DEVELOPMENT APPLICATION FORM

Project Name	11 North Andrews		
Project Description <i>(Describe in detail)</i>	Mixed-use development with 378 multifamily units and 5,605 square feet of commercial space, including a request for 62 additional flexibility units		
Estimated Project Cost	\$	<i>(Estimated total project cost including land costs for all new development applications only)</i>	
Waterway Use	No		
Flex Units	378	Redevelopment Units	0
Flex Acreage	0		
Residential Uses			
Single Family	0		
Townhouses	0		
Multifamily	378		
Cluster/Zero Lot Line	0		
Other	0		
Total <i>(dwelling units)</i>	378		
Residential Unit Mix	Efficiency / Studio	36	1-Bedroom 252
Affordable Housing Units	0	% of AMI	
Affordable Unit Mix	Efficiency / Studio	1-Bedroom	
Traffic Study Required	No		
Parking Reduction	No		
Public Participation	Yes		
Non-Residential Uses			
Commercial	5,605 SF		
Restaurant	0		
Office	0		
Industrial	0		
Other	0		
Total <i>(square feet)</i>	5,605 SF

**Development Review
Committee**

11 NORTH ANDREWS

LANDSCAPE PLAN
 GROUND FLOOR

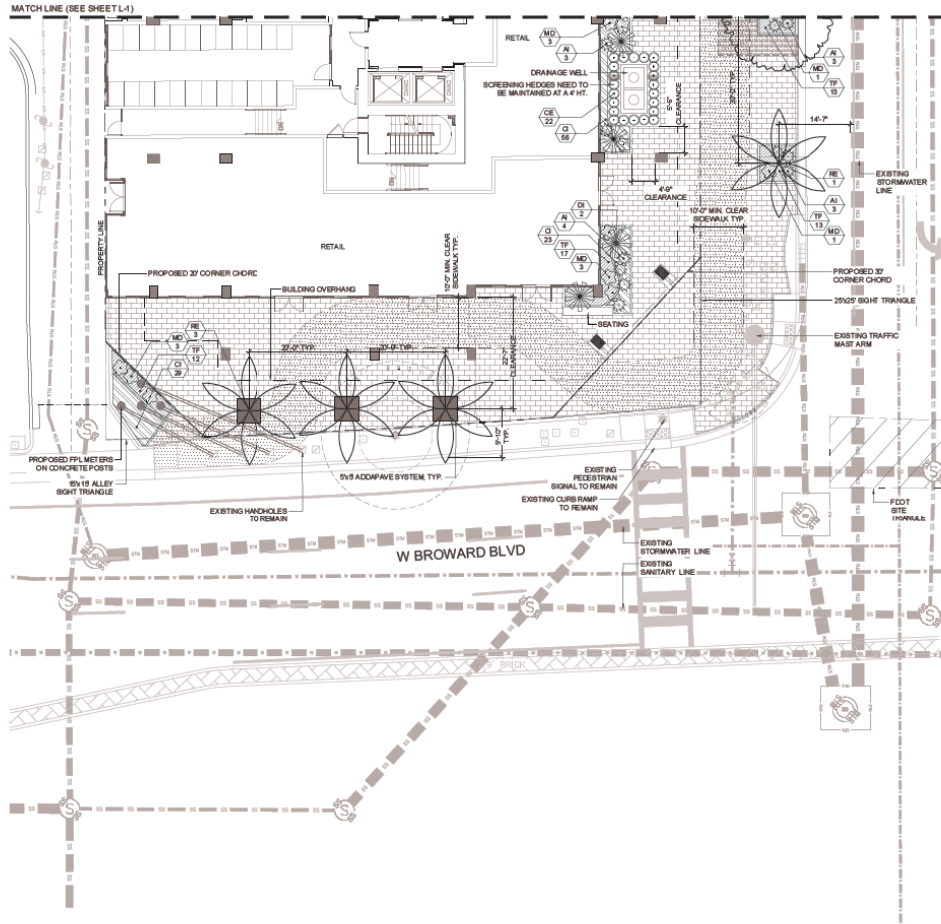
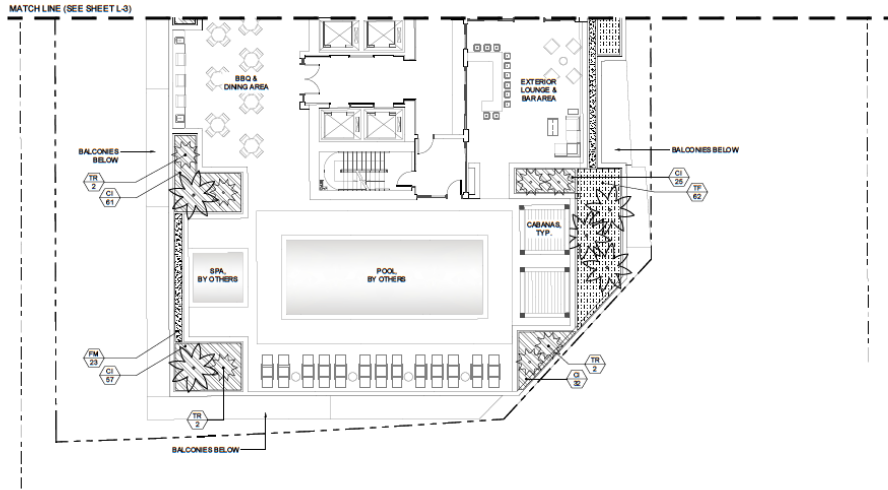
<p>S8 Reduce horizontal clearances for trees (Palms: 6ft; Shade: 12ft).</p> <p>Applicant's Response: Horizontal clearances (from building face) for trees and palms have been provided and shown on Landscape plans (see sheet L-1 and L-2).</p>
<p>S9 Encourage shade trees along streets, palm trees to mark intersections.</p> <p>Applicant's Response: Shade trees have been provided where existing and proposed conditions allow for it. Live Oaks have been proposed along N Andrews Avenue and NW 1st Street and Royal Palms have been proposed to mark intersections.</p>
<p>S10 Eliminate County “corner chord” requirement not compatible with urban areas.</p> <p>Applicant's Response: Broward County Plat Division requires that a 30-ft corner chord granted in the form of easement be provided at the intersection of N. Andrews Avenue and W. Broward Boulevard. A 30-ft corner chord granted in the form of easement is provided at the intersection of NW 1st Avenue and N. Andrews Avenue. A 20-ft corner chord granted in the form of easement is provided at the intersection of the public alleyway and W Broward Boulevard.</p>
